CITY OF ALBUQUERQUE

Re: Chase Bank - Eubank
340 Eubank Blvd NE
Traffic Circulation Layout
Engineer's/Architect's Stamp 09-02-2020 (K21-D009C)

TRAFFIC CIRCULATION PLAN

PLOT DATE	09/02/20
DRAWING SCALE	1" = 10'
PROJECT NUMBER	CDC20014
SHEET NUMBER	C1.02

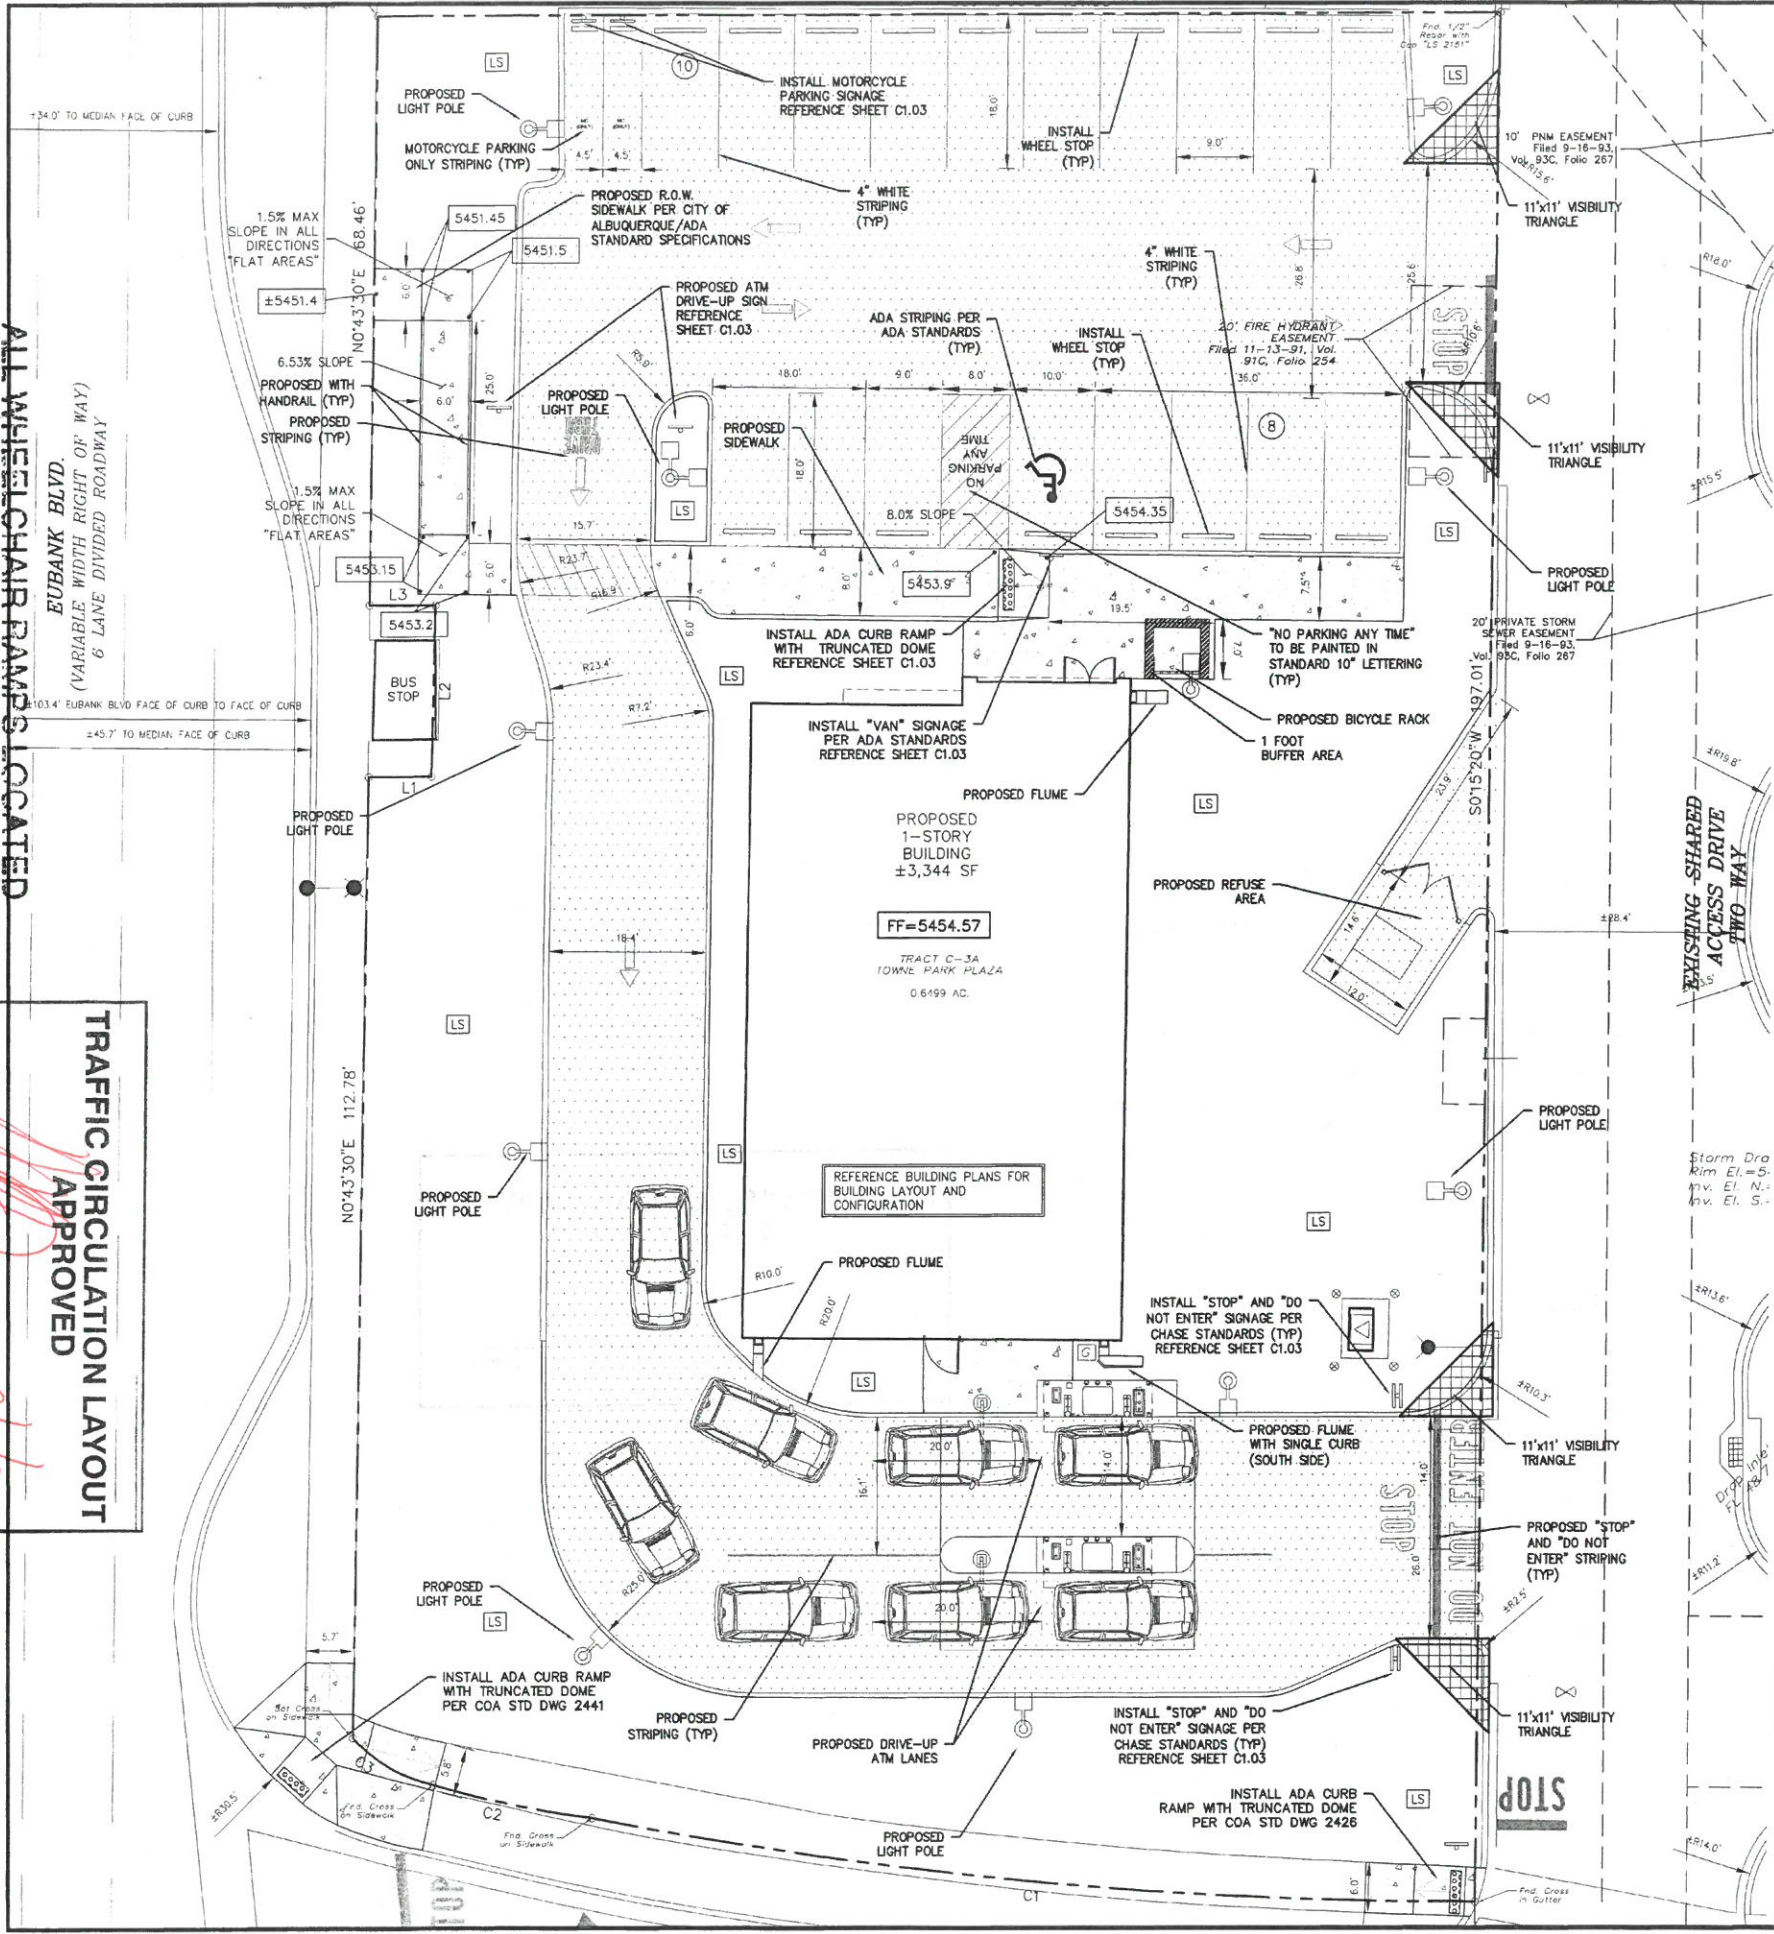
The TCL submittal received 09-02-2020 is approved for Building Permit with. A copy of the stamped and signed plan will be needed for each of the building permit plans. Please keep the original to be used for certification of the site for final C.O. for Transportation.

ALL WHEELCHAIR RAMP LOCATED
WITHIN THE PUBLIC RIGHT OF WAY
MUST HAVE TRUNCATED DOMES.
